Project: Firestone Complete Auto Care, Lee's Summit, MO
GSP# 40831.45

WATER QUALITY AS BUILT POND CALCULATIONS

GRADING AND
DRAINAGE PLAN

C300

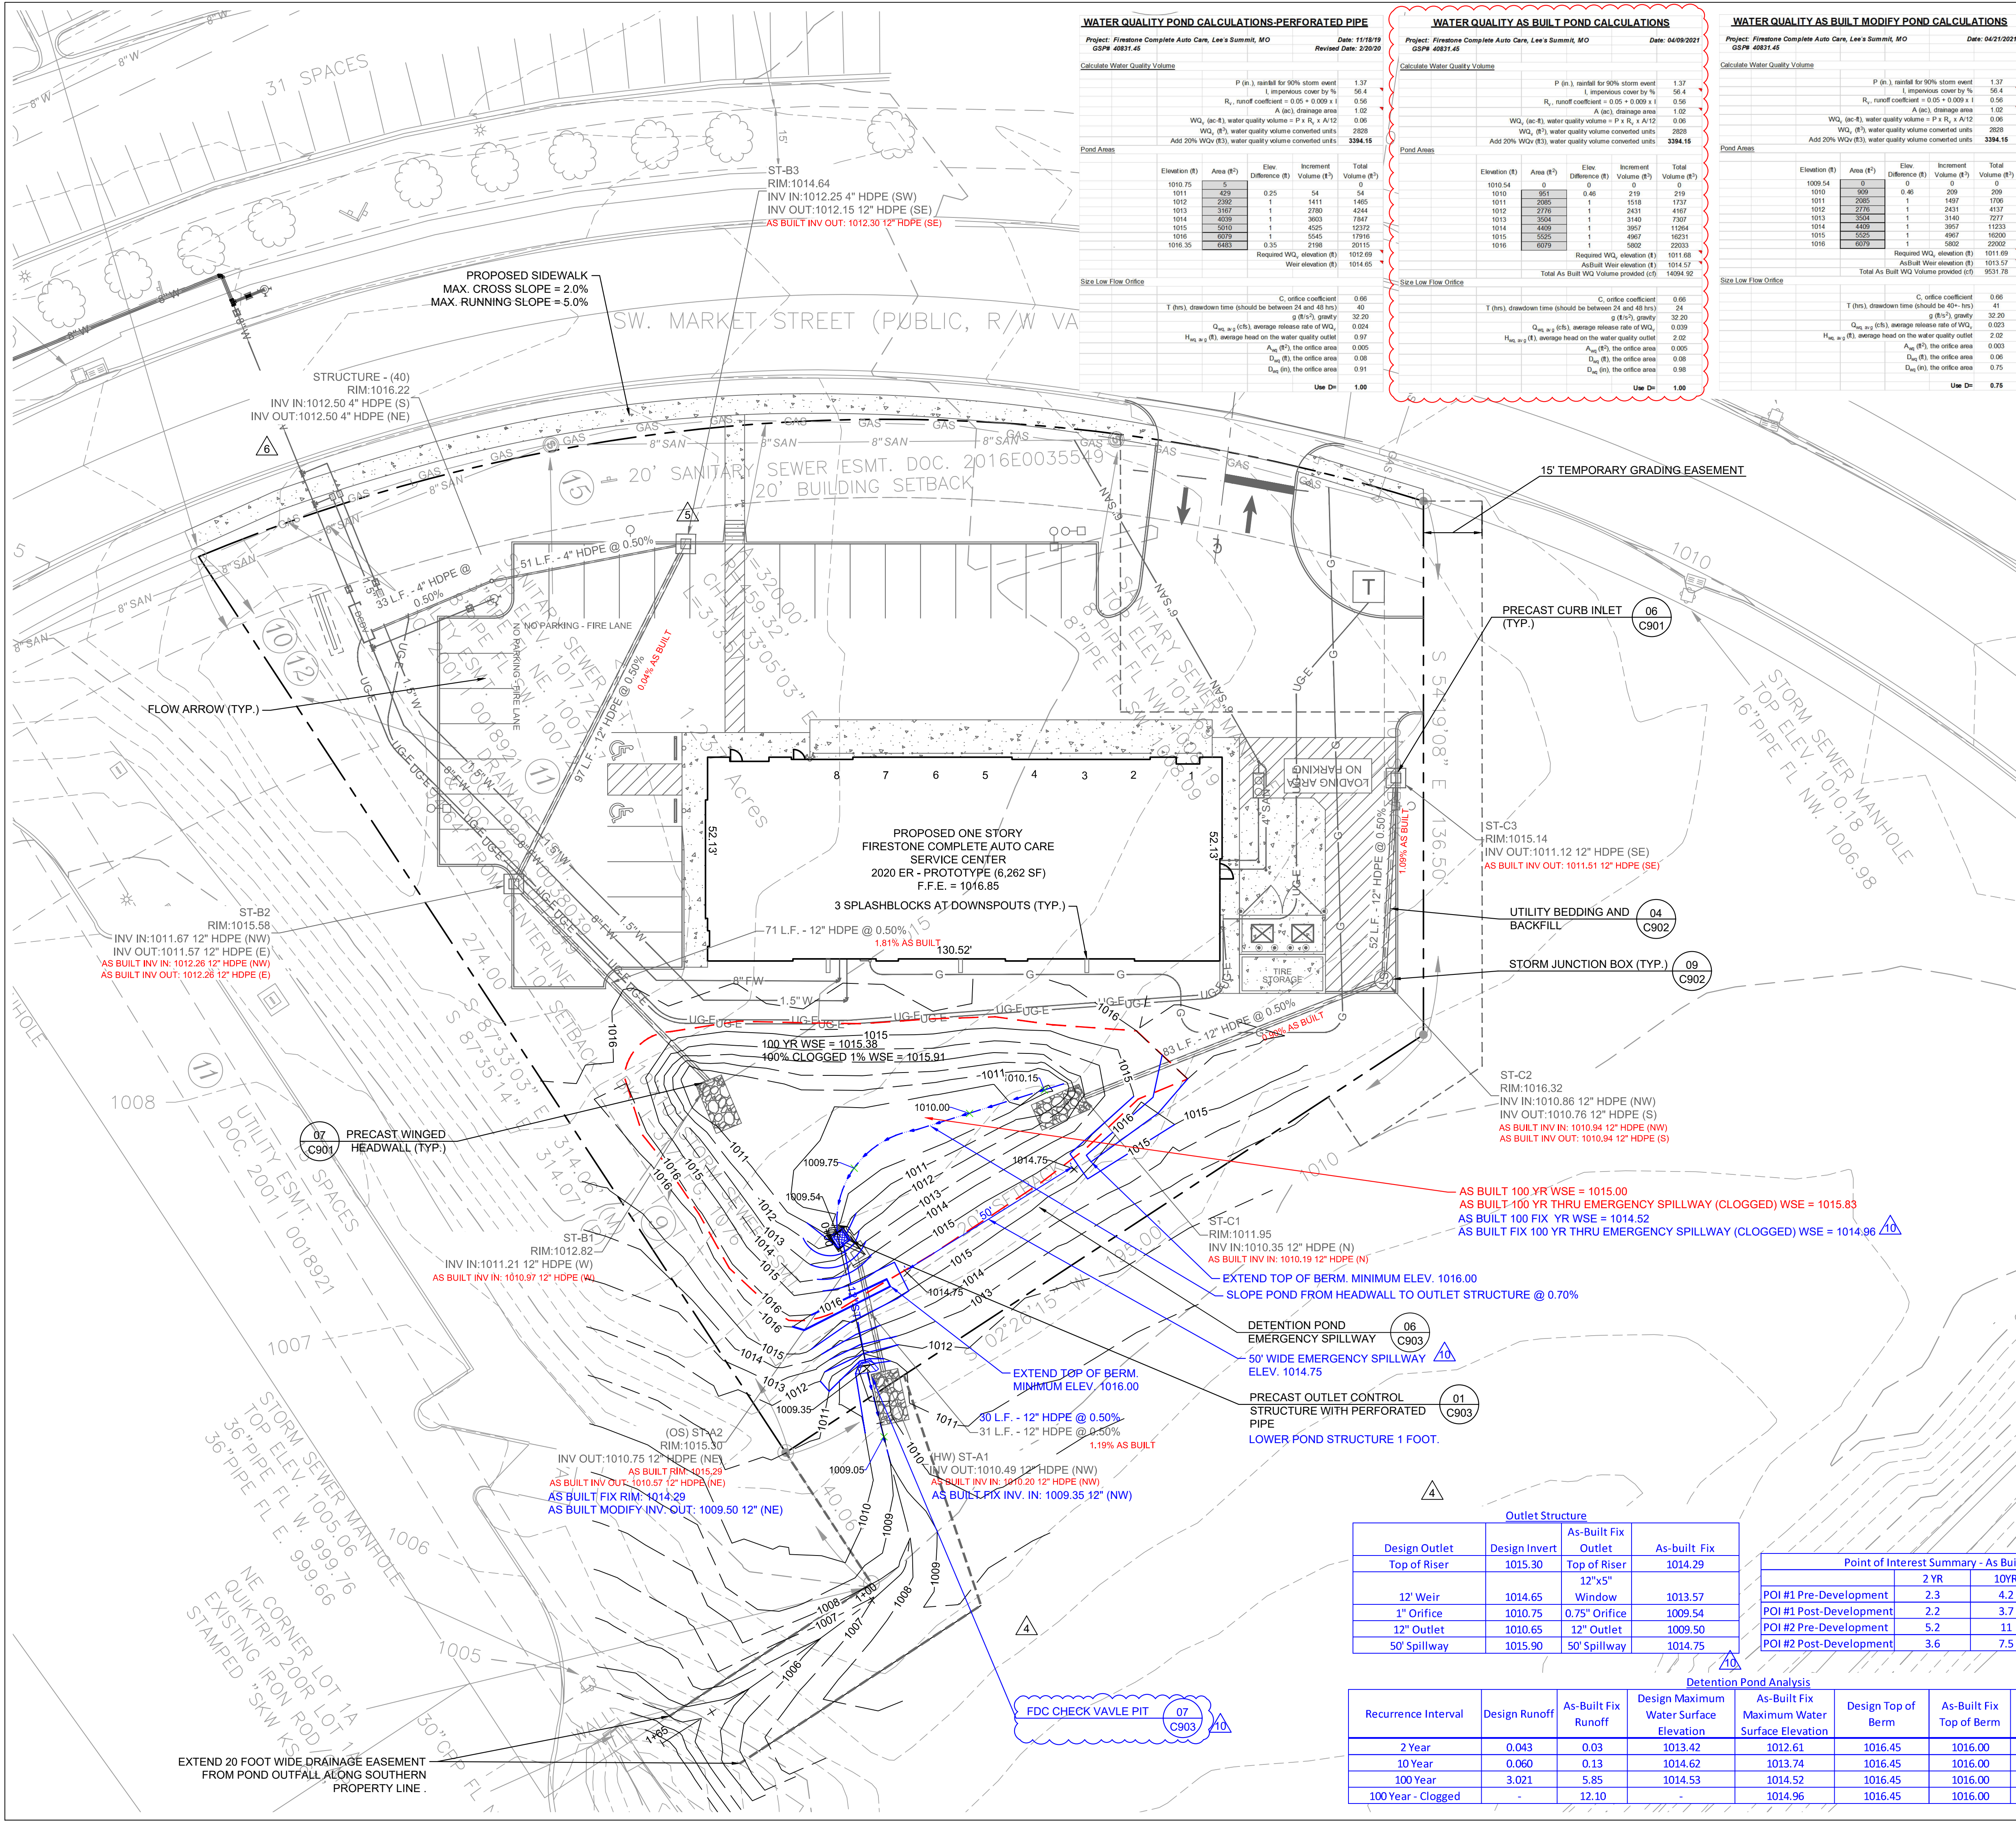
Elevation (ft)	Area (ft ²)	Elev. Difference (ft)	Increment Volume (ft ³)	Total Volume (ft ³)
1010.54	0	0	0	0
1010	867	0.46	219	219
1011	2085	1	1516	1737
1012	2776	1	2431	4167
1013	3504	1	3140	7707
1014	4409	1	3957	11664
1015	5525	1	4967	16631
1016	6079	1	5802	22433
Required WQ ₂ elevation (ft)				1011.69
Actual WQ ₂ elevation (ft)				1014.57
Total As Built WQ Volume provided (cfs)				14094.92

Elevation (ft)	Area (ft ²)	Elev. Difference (ft)	Increment Volume (ft ³)	Total Volume (ft ³)
1009.54	0	0	0	0
1010	909	0.46	269	269
1011	2085	1	1467	1736
1012	2776	1	2431	4167
1013	3504	1	3140	7707
1014	4409	1	3957	11664
1015	5525	1	4967	16631
1016	6079	1	5802	22433
Required WQ ₂ elevation (ft)				1011.69
Actual WQ ₂ elevation (ft)				1013.57
Total As Built WQ Volume provided (cfs)				9531.78

- FOR SITE PREPARATION AND GEOTECHNICAL RECOMMENDATIONS, REFER TO INTERTEK PSI GEOTECHNICAL REPORT 03381947, DATED 7/24/2019.
- ITEMS IN RED AND CLOUDED IN RED INDICATE AS BUILT CONDITIONS.
- ITEMS IN BLUE AND CLOUDED IN BLUE INDICATE AS BUILT FIX, ONCE FIX IS COMPLETED, PROVIDE TOPO SURVEY OF THE ENTIRE SITE INCLUDING PARKING, BUILDING FFE, AREA INLET TOP OF CASTING, POND, POND STRUCTURE INVERTS AND DIMENSIONS.

C, orifice coefficient	0.66
	T (hrs), drawdown time (should be 40+ hrs)	41
	g (ft/s ²), gravity	32.20
	Q _{avg w2} (cfs), average release rate of WQ ₂	0.023
	H _{avg w2} (ft), average head on the water quality outlet	2.02
	A _{or} (ft ²), the orifice area	0.003
	D _{or} (ft), the orifice area	0.06
	D _{or} (in), the orifice area	0.75
	Use D=	0.75

POND CONTOUR AREAS - AS BUILT FIX		
ASBUILT ELEVATION	ASBUILT modify CAD AREA (SF.)	ASBUILT CAD VOLUME (CF.) AVG. END METHOD
1009.54	0	0
1010.00	909	209
1011.00	2085	1,706
1012.00	2776	4,137
1013.00	3504	7,777
1014.00	4409	11,234
1015.00	5525	16,201
1016.00	6079	22,003
